# Test Pattern Generators and checkers.

802.3dj March 2025 Plenary Atlanta.

Mike Dudek      Marvell

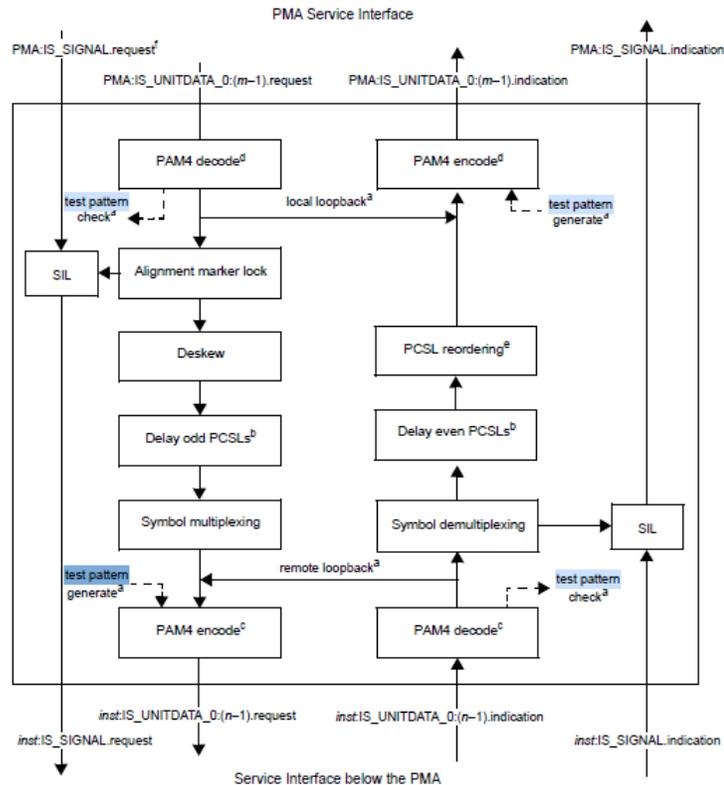
- There is ambiguity whether the test patterns are optional or required.
- It is never necessary to have the PRBS31 and PRBS31Q test patterns simultaneously.
- The PRBS31 is used for the Inner FEC, but not needed for xAUI-n or PMD's which use the PRBS31Q

Figure 176-2—200GBASE-R 8:1, 400GBASE-R 16:2, 800GBASE-R 32:4,  
1.6TBASE-R 16:8 PMAs functional block diagram

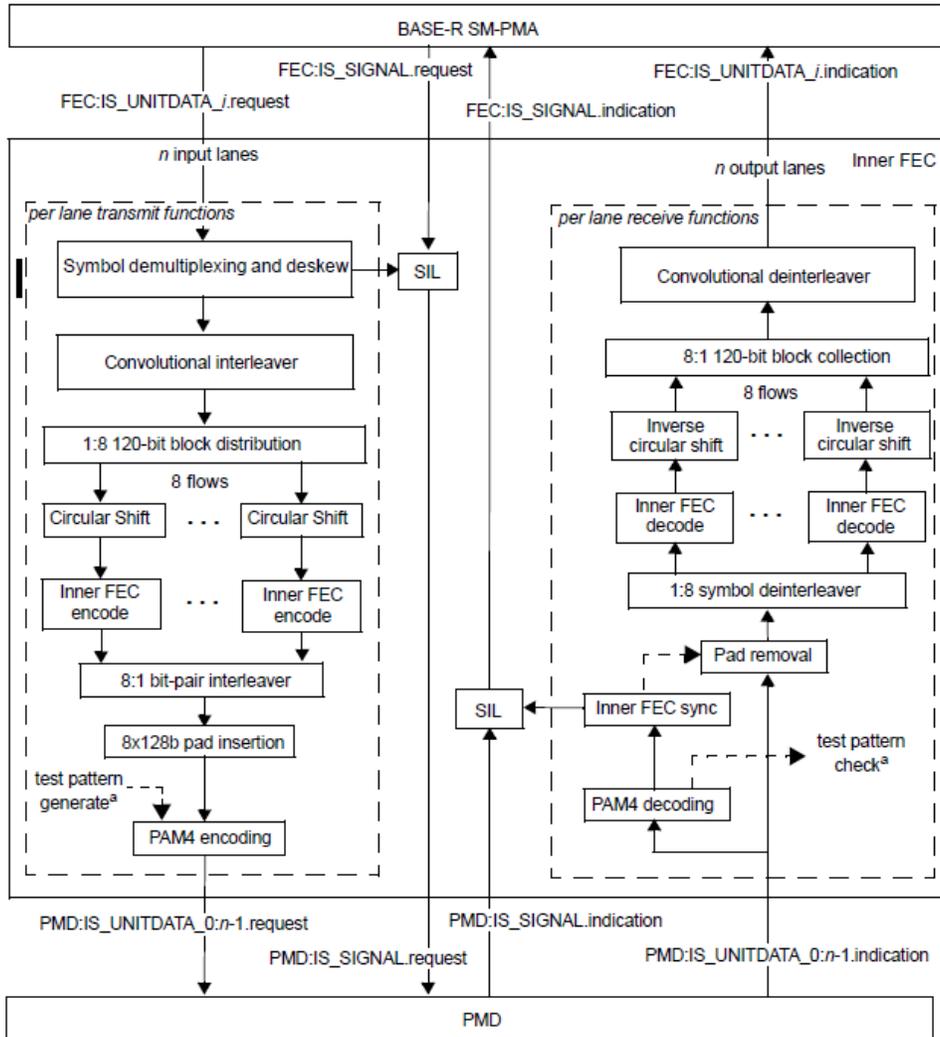
- Figure 176-2 shows the test pattern injection point. (Figure 173-3 is similar as are Figures 176-12 and 176-13)
- Injecting PRBS31Q at this point and further Gray coding it isn't what is intended. However the use of the optional pre-coder within the PAM4 encode process should be documented.
- Footnote a saying the test pattern generate and check are optional is not correct.

- Change the text in 176.7.4 to  
“Where the lanes of the PMA are connected to a physically instantiated interface xAUI-n, Inner FEC, or a PMD service interface, the PMA generates and detects test patterns. These test patterns are used to test adjacent layer interfaces for an individual PMA sublayer or to perform testing between a physically instantiated interface of a PMA and external testing equipment.

- Change the text in 176.7.4 .1 to  
“A PMA connected to an Inner FEC shall include a PRBS31 pattern generator and checker as specified in [120.5.11.1.1](#). “

- Change the text in 176.7.4.2 to  
“A PMA connected to an xAUI-n or PMD service interface shall include a PRBS31Q pattern generator and checker as specified in [120.5.11.2.2](#).”

- In Figures 176-2, 173-3, 176-12 and 176-13 remove the footnote saying “optional” on the test pattern generators and checkers. Relabel the existing injection points PRBS31 test pattern generate and PRBS31 test pattern check. Split the PAM4 encode and decode into “Gray mapping” and “Precoding”. Add “test pattern generate (except PRBS31)” and “test pattern check (except PRBS31)” injection points between the “Gray mapping” and “Precoding”.

- Change 176.7.4.7 (PMA clock error detection and counters) from “Each PRBS31Q test pattern checker shall include block error detection .....” to “Each PRBS31Q test pattern checker and PRBS31 test pattern checker shall include block error detection.....”

- Add Management variables and MDIO registers for the PRBS31 generator, checker and counters.

- Change the text in 176.7.4 to  
“Where the lanes of the PMA are connected to a physically instantiated interface xAUI-n, Inner FEC, or a PMD service interface, the PMA generates and detects test patterns. These test patterns are used to test adjacent layer interfaces for an individual PMA sublayer or to perform testing between a physically instantiated interface of a PMA and external testing equipment.

- Change the text in 176.7.4 .1 to  
“A PMA shall include a PRBS31 pattern generator and checker as specified in 120.5.11.1.1. “
- Change the text in 176.7.4.2 to  
“The PRBS31Q test pattern generator and checker are the PRBS31 test pattern generator and checker as defined in 176.7.4.1 Gray encoded by the Gray mapping defined in 176.7.1.1.”

- In Figures 176-2, 173-3, 176-12 and 176-13 remove the footnote saying “optional” on the test pattern generators and checkers. Relabel the existing injection points PRBS31 test pattern generate and PRBS31 test pattern check. Split the PAM4 encode and decode into “Gray mapping” and “Precoding”. Add “test pattern generate (except PRBS31)” and “test pattern check (except PRBS31)” injection points between the “Gray mapping” and “Precoding”.

- Change 176.7.4.7 (PMA clock error detection and counters) from “Each PRBS31Q test pattern checker shall include block error detection .....” to “Each PRBS31 test pattern checker checker shall include block error detection.....”

- Change the Management variables and MDIO registers to PRBS31 instead of PRBS31Q.
